Re: Aspect Industrial Estate, Mamre Road – Request for Further Information

The following table provides our response to the request for additional information received from the Department of Planning Industry and Environment (DPIE), Transport for New South Wales (TfNSW), Penrith City Council (Council) and other key stakeholders in relation to SSD-10448.

Figure 23: Stage 1 2026 SIDRA Intersection Layout

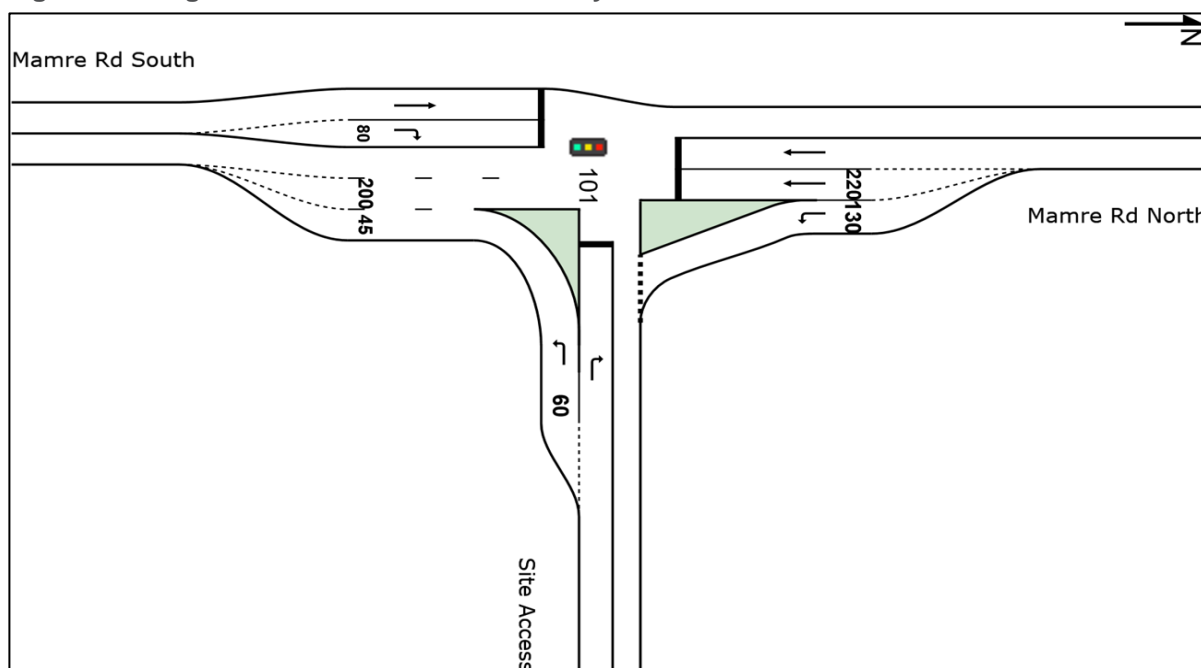
3g.	<p>Section 7.8 Figure 18 - Stage 1 2026 SIDRA Intersection Layout – Pedestrian crossings have not been provided on all legs of the proposed signalised intersection within the SIDRA modelling provided. An exemption from TfNSW is required should a pedestrian crossing not be provided on all legs. It is therefore required that pedestrian crossings are provided on all legs and the modelling is updated to reflect this.</p>	<p>Pedestrian demands are anticipated to be low on all crossings prior to the implementation of bus services or employee services within the precinct. Notwithstanding, modelling has been updated in the revised TMAP and now includes crossings on all approaches to the intersection.</p>
3h.	<p>Section 7.8.3 - it noted on the report that "one of TfNSW's currently key transport movement and outcome is to achieve a LOS E or better for the MR Precinct intersections". This statement is incorrect and should be removed from any report. TfNSW would expect any new intersection to perform as an average at LOS C or better</p>	<p>The Mamre Road Precinct Road Network – Transport and Movement Outcomes report, provided by DPIE / TfNSW to Mirvac (as part of the Mamre Road Land Owners Group) stipulates in Section 2. Road Network (External and Internal) a design Level of Service Threshold as follows:</p> <ul style="list-style-type: none"> • For existing and new intersections LOS E or better <p>This is contrary to the submission by TfNSW and clarification is therefore sought.</p>
